**Subject: SP25-018 Parker & Pine F1 L4 – Car Wash Canopies – Site Plan Amendment**

Revised documents for SP25-018 have been submitted. Below is a short narrative of the required revisions

# SITE PLANS

## PARKER AND PINE FILING NO.1 LOT 4 - CAR WASH

SITE PLAN  
SHEET TITLE  
SHEET NUMBER

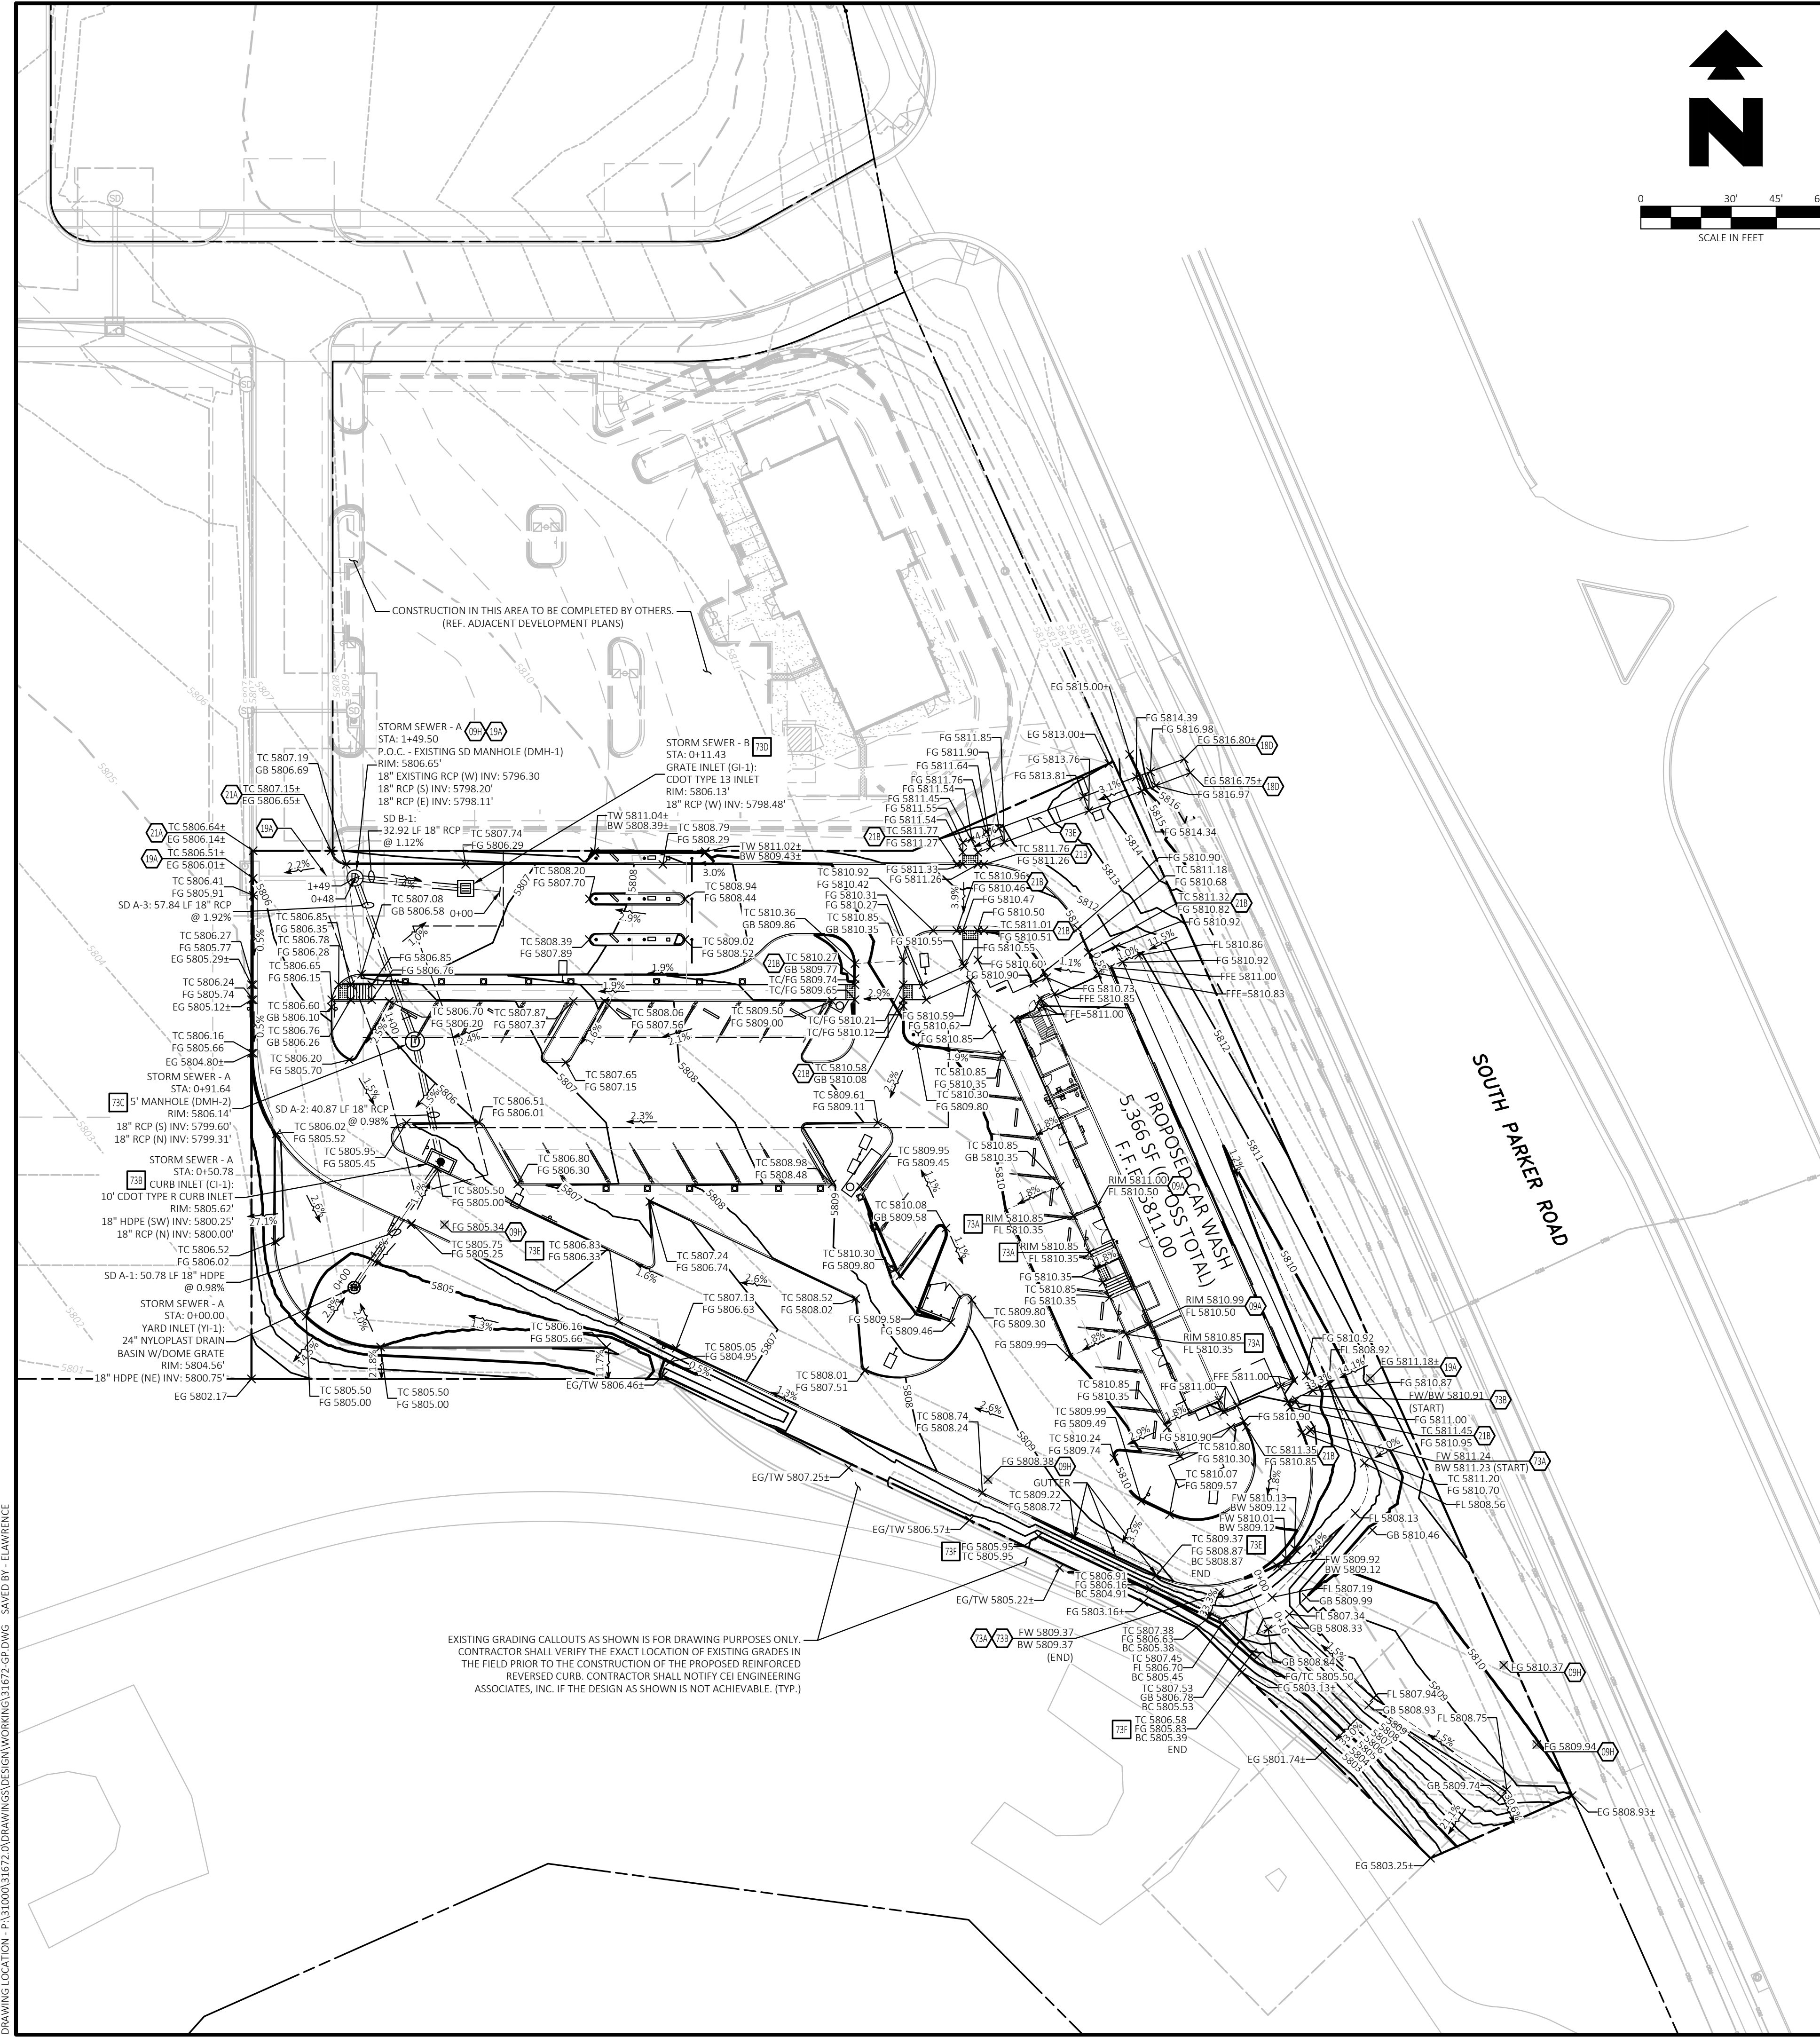
1. The Civil Site plan has been revised to depict asbuilt conditions.
2. The Utility plan added notes to existing utility equipment.
3. The Landscape plan has been revised to show revised placement of plant stock due to added concrete pads.
4. The Architectural Exterior Elevations have been revised to depict asbuilt conditions, including canopies.
5. The Photometric plan has been updated to depict asbuilt conditions.
6. Parker Engineering comments have been addressed in an updated Drainage Letter.
7. Xcel Energy comments have been discussed with Xcel (Donna George) and no issues exist.
8. Stamped Canopy plans have been uploaded separately for a second Building Department review under COM23-0034. The Planning compliance revisions to the canopies (fascia detail) are also included on this set.
9. Exterior equipment screening is in production and will be installed in approximately 1 week.

## 01 PHOTOMETRIC SITE PLAN

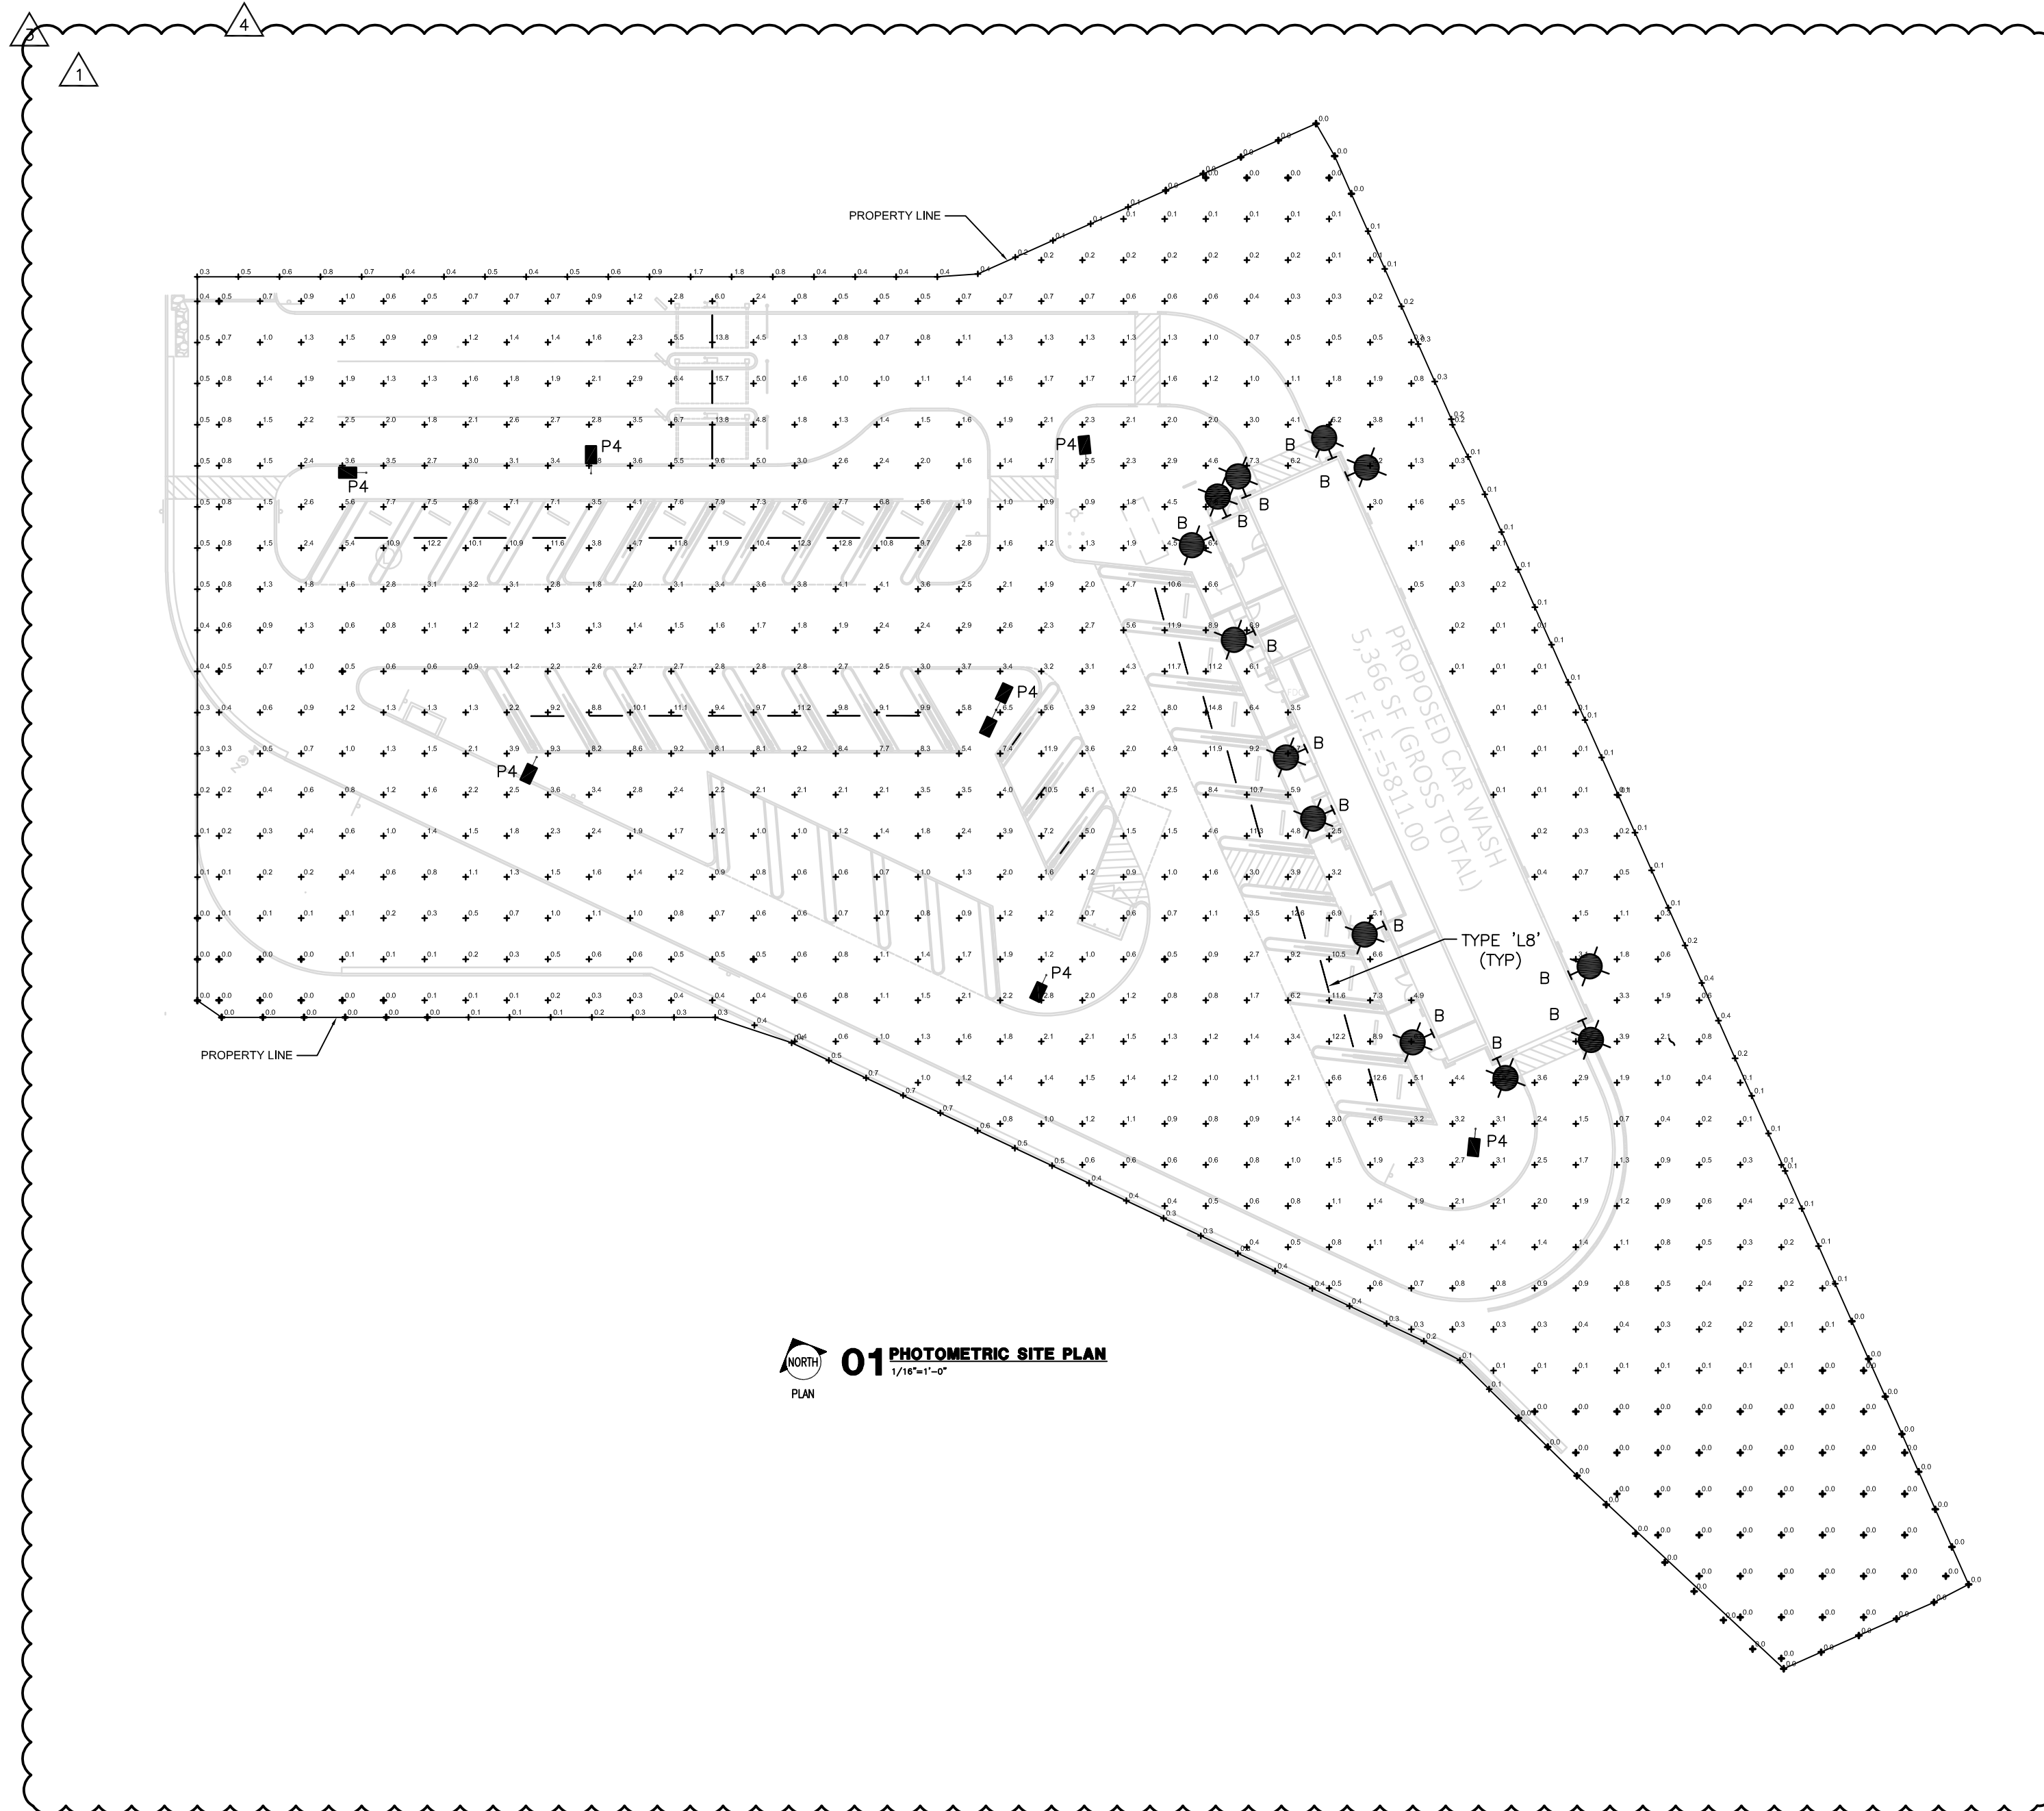
Sheet	Description	Summary
ES1.0	Photometric Site Plan	<p>Removed 3 lights from building.</p> <p>Revised all building lights to type B per site photo.</p> <p>Revised vacuum light L2 to L8 and changed location of light under canopy.</p> <p>Removed lights that turned into parking spots</p> <p>Re-calculated photometric per updated lights, revised lighting calculation summary.</p> <p>Removed light fixtures from light fixture schedule.</p> <p>Revised type B and L8 in light fixture schedule.</p>
ES1.1	Exterior Lighting Spec. Sheets	<p>Removed light fixture specification sheets that didn't apply to site conditions.</p> <p>Revised light fixture specifications sheets for light type B per site conditions.</p>
